VILLAGE OF MORTON GROVE  
**APPEARANCE COMMISSION**

Re: Appearance Commission Case AC 24-15

## STAFF REPORT

# A NEW SITE EXPANSION FOR POKO LOKO EARLY LEARNING CENTER SITE DEVELOPMENT PLAN

Proposed Site Plan – (ORANGE) Location of proposed playground facility; (RED) Vacated Playground  
(Source: Poko Loko School Inc.)

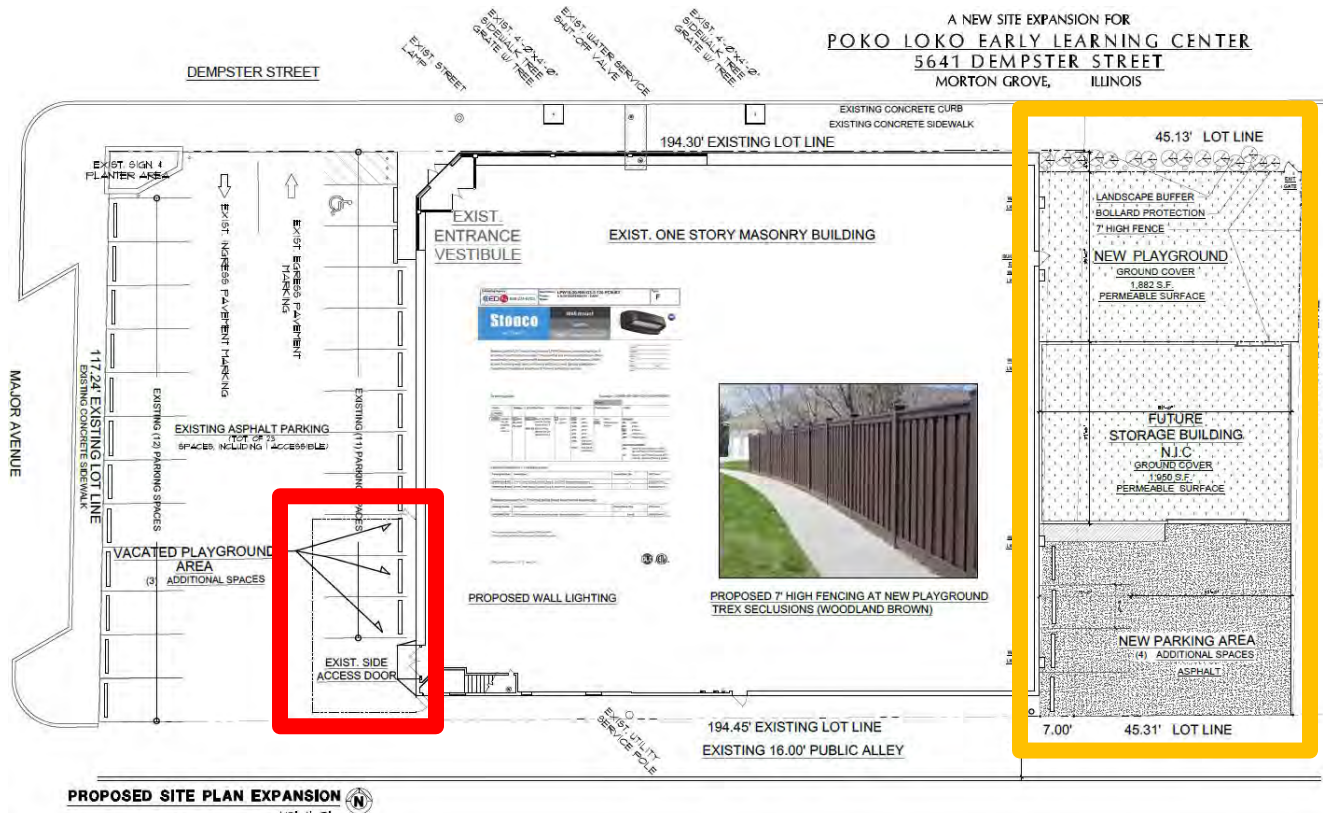
The proposed playground would be 1,882 sq. ft. in area and occupy the northern portion of the subject property. No renderings or material samples were provided regarding the type, size, and color of the proposed playground equipment. It is not clear what, if any, playground equipment would be visible from the Dempster Street right of way if the proposed fence and landscape bed were installed as proposed. **The applicant should speak to what type of equipment is desired for the playground area.**

The proposed landscape bed along the subject property's Dempster Street frontage is approximately 188 sq. ft. The type of shrubs proposed for the landscape bed are not defined in the application materials. **The applicant should speak to the plantings proposed for the Dempster Street frontage landscape bed.**

The central portion of the site is proposed to be reserved as open space that will be improved in the future with a storage building. It is not clear from the application materials what the surface of the central open space would consist of, but to ensure compliance with Section 12-11-1:B, at least 332 sq. ft. of the area must be landscaped or sodded. Notes indicate it would be "permeable ground cover." **The applicant should speak to how the proposed project would meet minimum landscape requirements as a whole, and how the central open space area would be landscaped or otherwise improved.**

*Shield Accessories Available for the Proposed Light Fixture*

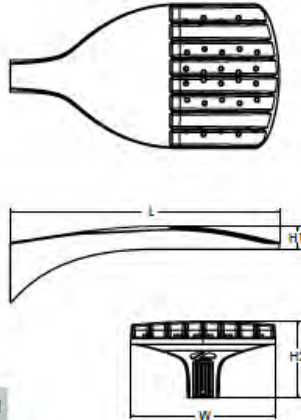
The applicant had previously indicated that the selected fixture would have a Neutral white” light temperature (4000 Kelvin). The currently proposed fixture has a variety of color temperatures available ranging from 2700-5000K. **The applicant should speak to the color temperature desired.**

Per Section 12-4-3:B.5, lighting of parking and loading areas must be a minimum of one foot-candle on the surface. However, such lighting must be confined to the property boundary and reach as close to zero illumination at the property boundaries as possible. Glare may not be evident from surrounding properties or adjacent public rights of way. As proposed, light levels along the north lot lint (along Dempster Street) and the south lot line (adjacent the alley) range between 0.3 and 0.6 foot candles. The photometric specifications appear to indicate that the proposed fixture will include a “house side shield” that will prevent spillover onto the adjacent property to the east, and light levels along the west property line are shown to be 0.0. **The applicant should confirm that the house side shield would be installed and speak to anticipated light levels at property edges including the Dempster Street frontage.**
